IB19-E-001A

FTR FRONT END NOISE

- 2018-2020 MY Isuzu FTR vehicles produced prior to January 10, 2019

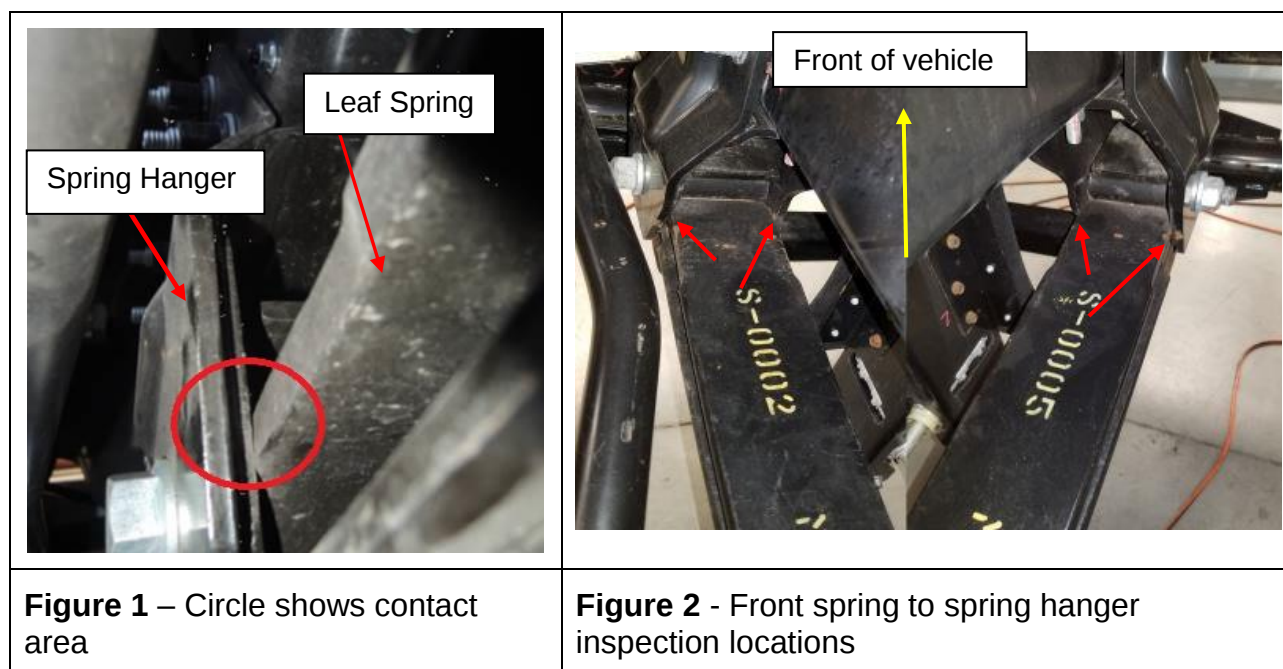
Some customers may complain about a clunking noise coming from the front end typically heard when turning into an uneven road surface or while turning and hitting a bump. This clunking noise may be caused by the front leaf spring contacting the spring hanger as shown in Figure 1.

Inspect the four locations at the front spring forward hanger, as shown with red arrows in Figure 2, for evidence of contact. If evidence of contact is present, replace both front leaf springs with updated leaf springs by following the procedure set forth in the applicable WSM. This will increase the clearance and prevent contact in the future. (See Table 1.)

Part Number	Description	QTY
8-97532-429-0	LH Front Leaf Spring	1
8-97532-430-0	RH Front Leaf Spring	1
